SERVICE BULLETIN

NO. FAS-030

Fuji Heavy Industries, Ltd.

1. SUBJECT : Provision of rubber seal on front canopy stay.
2. AIRCRAFT AFFECTED : FA-200 Serial Nos. 1 through 86.
3. PRIORITY : Essential.
4. REASON : In order to prevent canopy glass damage or vibration noise in case that the glass comes in contact with the stay at high speed flight.
5. DESCRIPTION : Provision of rubber seal on front canopy stay.
6. ACCOMPLISHMENT : This instruction shall be accomplished within 25 hours after receipt of this bulletin.
7. APPROVAL : JCAB Approval NO-TOKYO-004 July 22, 1970
8. PARTS REQUIRED : The following parts, adhesive not included, shall be furnished owner without fee.

Front canopy stay

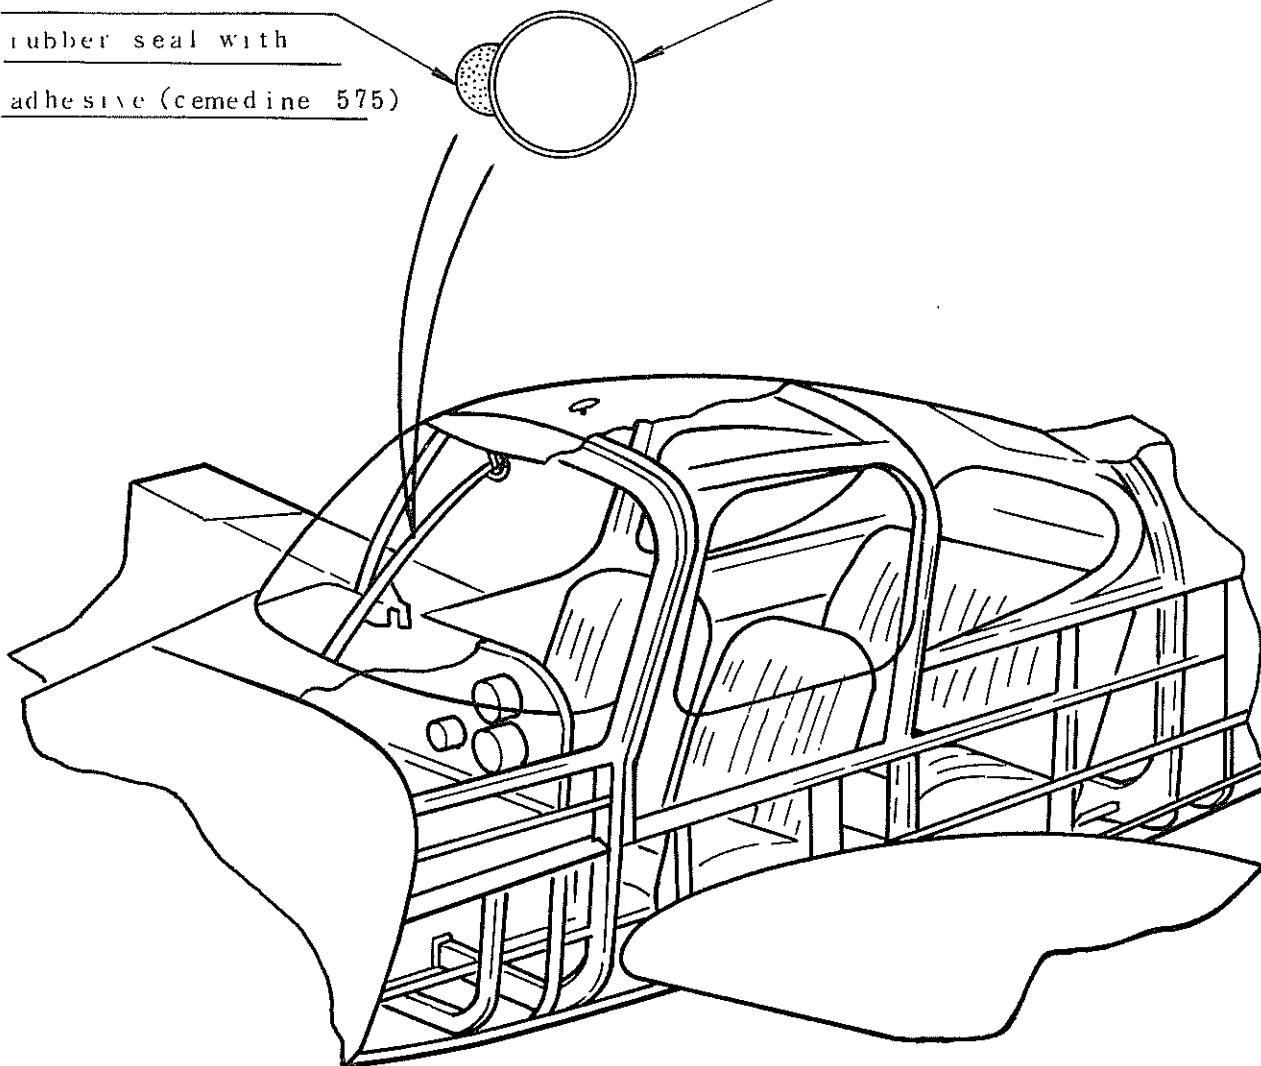
Bond #0483-10700
rubber seal with
adhesive (cemedine 575)

13. WORK PROCEDURE : After cleaning bonded area of stay, bond
the rubber seal with adhesive.

Caution When bonding rubber seal, care shall be exercised so as not to apply adhesive on the front glass. Masking the affected glass area with paper or other proper material is recommended.
